Access Compliance Report

Public Rights-of-Way

Intersection ID: 30000	Main Street: OAKBORO_LN	Cross Street: OLD_CAROLINA_DR	Location: NW
ADA ID: AE09FE5202A7	Ramp Type: PerpDiag	Initial Pass/Fail: Fail	Overall Compliance: No
		Severity Score: 21.25

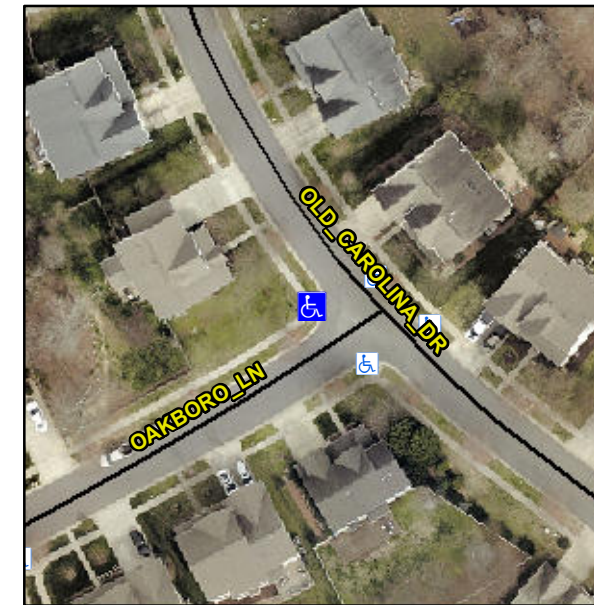
Not Found, R304.5.1, R304.5.3

Compliance	Description	Data	Compliance	Description	Data
N/A	Ramp Length (in)	70.0	Yes	Ramp Slope (%)	6.0
No	Ramp Width (in)	47.5	No	Ramp XSlope (%)	5.1
N/A	Flare Type LT	N/A	N/A	Flare Type RT	N/A
N/A	Flare Slope LT (%)	N/A	N/A	Flare Slope RT (%)	N/A
N/A	Flare Traversable LT?	N/A	N/A	Flare Traversable RT?	N/A
N/A	Landing Length (in)	N/A	N/A	DWS Provided?	N/A
N/A	Landing Width (in)	N/A	N/A	DWS Contrast?	N/A
N/A	Landing Slope (%)	N/A	N/A	DWS Length (in)	N/A
N/A	Landing X Slope (%)	N/A	N/A	DWS Full Width?	N/A
N/A	Landing Curb? (Y/N)	N/A	N/A	DWS Offset (in)	N/A
N/A	Shared Landing?	N/A			
N/A	Gutter Ponding?	N/A	N/A	Gutter Slope (%)	N/A
N/A	Gutter Lip Ht (in)	N/A	N/A	Gutter X Slope (%)	N/A
N/A	Painted X Walk1?	No	N/A	Painted X Walk2?	No
	X Walk 1 Direction	To S		X Walk 2 Direction	To E
N/A	X Walk 1 Width (in)	N/A	N/A	X Walk 2 Width (in)	N/A
	X Walk 1 Slope (%)	0.9		X Walk 2 Slope (%)	0.7
	X Walk 1 X Slope (%)	1.0		X Walk 2 X Slope (%)	1.0

Remove & Replace Curb Ramp With Two New Directional Ramps or Equivalent.
